To: Members of Dublin City Council

Re: Ordinance 76-14 (Amended) – Establishing a new Bridge Street District Zoning District (BSD Scioto River Neighborhood District) and related Code Amendments for the BSD Scioto River Neighborhood to Sections 153.058, 153.059, 153.060, 153.062, 153.063, 153.065 of the City of Dublin Codified Ordinances (Zoning Code). (Case 14-039ADMC)

Proposed BSD Scioto River Neighborhood District Graphic | Figure 153.063-D

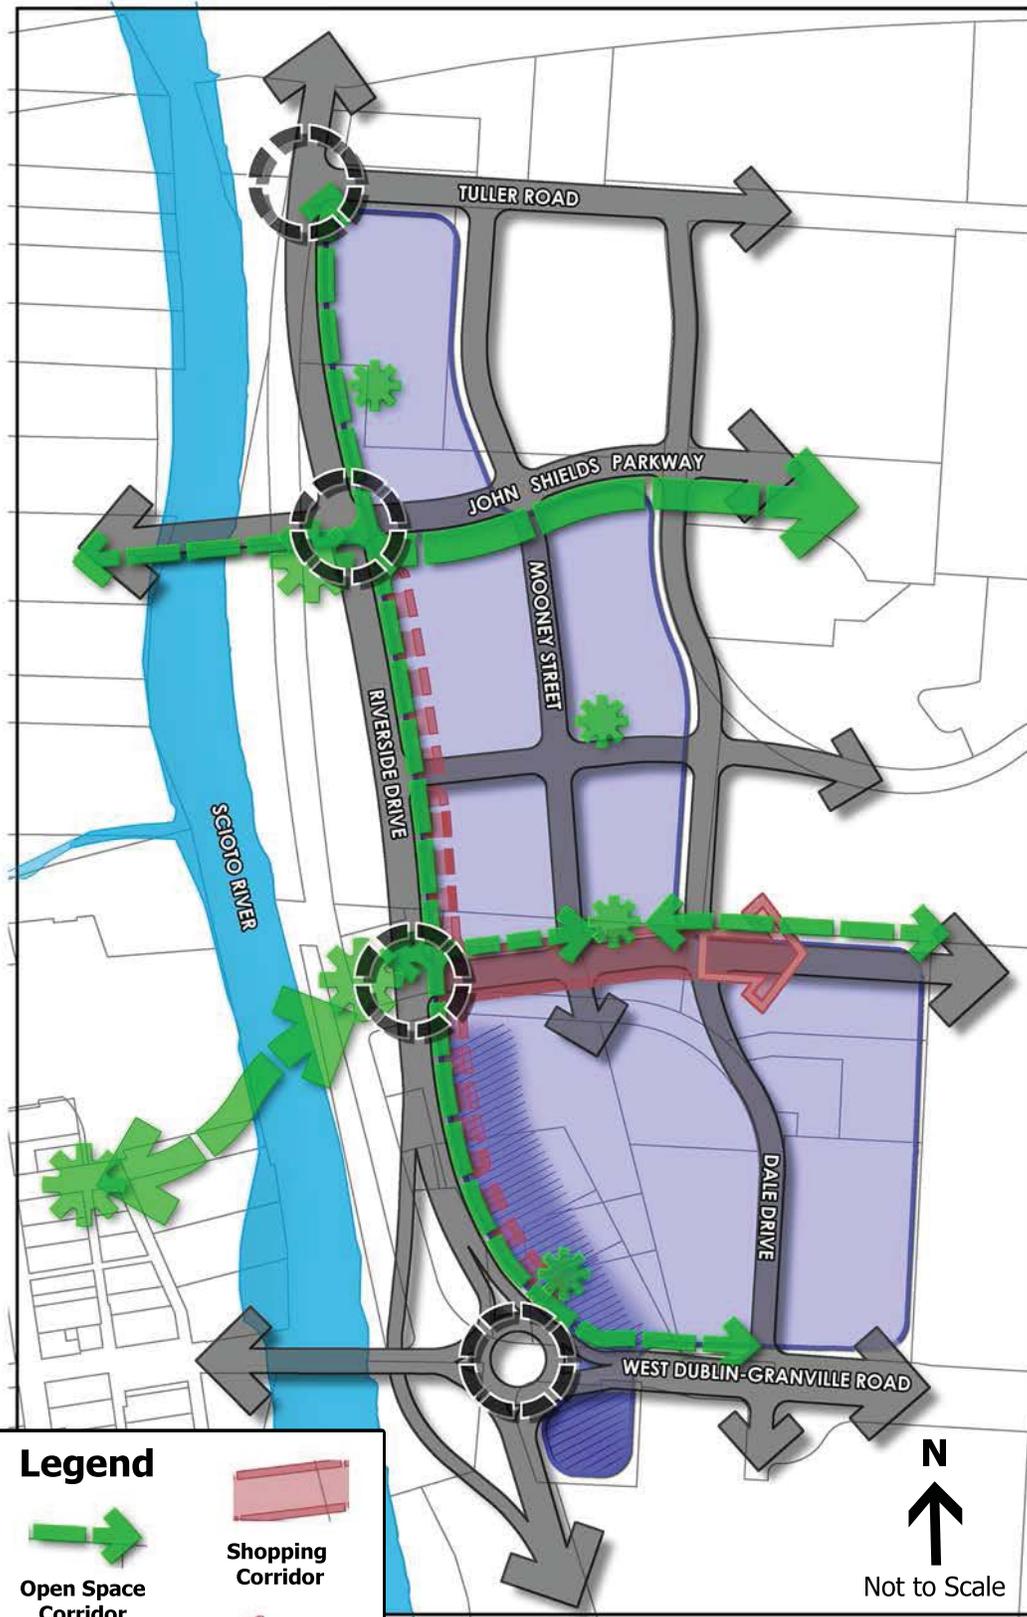
- Adding an intent statement for the new BSD Scioto River Neighborhood District.
- Adding development standards (mirroring the existing BSC Sawmill Center and BSC Indian Run Neighborhood Districts).
- Providing a conceptual graphic that coordinates with the recommended zoning for the Scioto River Neighborhood District. The graphic depicts major street network connections, demonstrates how the open space network complements desired development and respects existing natural features, identifies opportunities to establish gateways, and illustrates generally where the key mixed-use center ("shopping corridor") is desired and could be extended.

Ms. Ray referred to the updated Riverside Neighborhood District graphic and noted the updates, including an arrow at the east end of the shopping corridor for a mixed use activity node, a designation on the graphic indicating limited vehicular access adjacent to the roundabout at the intersection of Riverside Drive and State Route 161, and modifications to the boundaries of this district consistent with the modifications to the zoning map.

(2) Refer to §153.058 for the BSD Scioto River Neighborhood District intent, and refer to the revised Zoning Map for the actual limits of the BSD Scioto River Neighborhood District. Refer to Figure 153.063-D for an illustration of a conceptual development pattern desired for this district.

2. At least one continuous shopping corridor is required and shall be located on and perpendicular to a principal frontage street in the approximate location shown on Figure 153.063-D.

2. The open space network shall be provided, at a minimum, in the approximate locations shown in Figure 153.063-D. Open space locations shall be approved with the Site Plan Review, but locations and types shall be identified with the Development Plan Review and shall meet the following criteria:
